SERVICE INSTRUCTION

Service Instruction No. 1458B
(Supersedes Service Instruction No. 1458A)
Engineering Aspects are
FAA Approved

SUBJECT: Connecting Rod Bolts

MODELS AFFECTED: All Textron Lycoming reciprocating aircraft engines.

Connecting Rod Bolt Nut

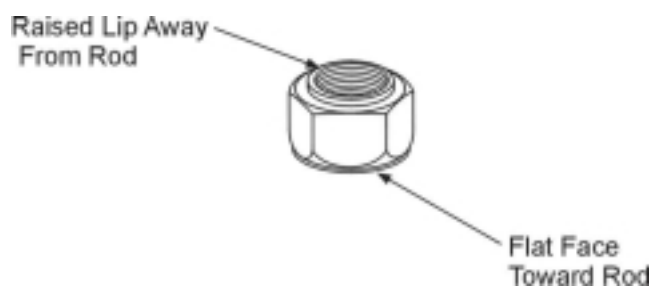
TORQUE BOLTS: Torque bolts must be tightened using a calibrated torque wrench. If a torque bolt yields before reaching the specified torque value (40 ft.-lbs.), the bolt must be returned to Textron Lycoming.

STRETCH BOLTS: If 35 ft.-lb. of torque fails to give minimum stretch (2.255 length) additional torque can be applied until proper stretched length results. If 35 ft. lb. results in an over-stretched bolt (greater than 2.256 length) it must be replaced. Considering possible variables in the joint that could increase the torque required to achieve specified stretch, including thread irregularities and possible dirt, a maximum torque of 55 ft.-lb. is hereby recommended for assembling connecting rods with stretch bolts. The recommended range of torque for assembling connecting rods with stretch bolts is the following (thread lubrication with Loctite 51168 Food Grade Anti-Seize Lubricant is a requirement to fall within specified stretch limits):

Initial Torque: 35 ft.-lb.
Maximum Torque: 55 ft. lb.

If proper stretched length (2.2550/2.2560) is not achieved within these values, the bolt must be discarded and replaced.

THE CONNECTING ROD BOLT CANNOT BE TIGHTENED CORRECTLY IF THE NUT IS INSTALLED UPSIDE DOWN. THE RAISED EDGE, OR LIP ON THE ONE FACE OF THE NUT MUST BE ON THE FREE END OF THE BOLT; THE FLAT FACE MUST BE IN CONTACT WITH THE ROD. SEE FIGURE.
